# Access Compliance Report

## Public Rights-of-Way

### (Curb Ramps)

Intersection ID: 24469	Main Street: MIROW_PL	Cross Street: SAINTFIELD_PL	Location: NW
ADA ID: 1099112B1857	Ramp Type: PerpDiag	Initial Pass/Fail: Fail	Overall Compliance: No
		Severity Score: 30

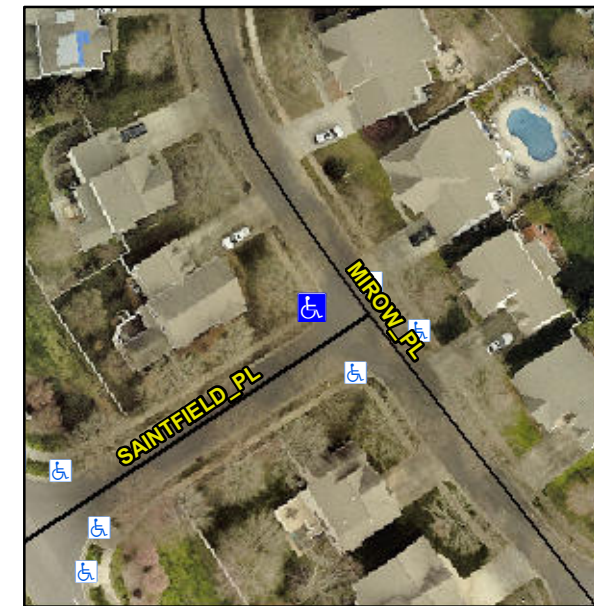
**R304.5.1, R304.2.2**

Compliance	Description	Data	Compliance	Description	Data
N/A	Ramp Length (in)	46.0	No	Ramp Slope (%)	10.8
No	Ramp Width (in)	35.0	Yes	Ramp XSlope (%)	1.8
N/A	Flare Type LT	N/A	N/A	Flare Type RT	N/A
N/A	Flare Slope LT (%)	N/A	N/A	Flare Slope RT (%)	N/A
N/A	Flare Traversable LT?	N/A	N/A	Flare Traversable RT?	N/A
N/A	Landing Length (in)	N/A	N/A	DWS Provided?	N/A
N/A	Landing Width (in)	N/A	N/A	DWS Contrast?	N/A
N/A	Landing Slope (%)	N/A	N/A	DWS Length (in)	N/A
N/A	Landing X Slope (%)	N/A	N/A	DWS Full Width?	N/A
N/A	Landing Curb? (Y/N)	N/A	N/A	DWS Offset (in)	N/A
N/A	Shared Landing?	N/A			
N/A	Gutter Ponding?	N/A	N/A	Gutter Slope (%)	N/A
N/A	Gutter Lip Ht (in)	N/A	N/A	Gutter X Slope (%)	N/A
N/A	Painted X Walk1?	No	N/A	Painted X Walk2?	No
	X Walk 1 Direction	To S		X Walk 2 Direction	To E
N/A	X Walk 1 Width (in)	N/A	N/A	X Walk 2 Width (in)	N/A
	X Walk 1 Slope (%)	6.2		X Walk 2 Slope (%)	7.8
	X Walk 1 X Slope (%)	3.3		X Walk 2 X Slope (%)	6.3

**Remove & Replace Curb Ramp With Two New Directional Ramps or Equivalent.**
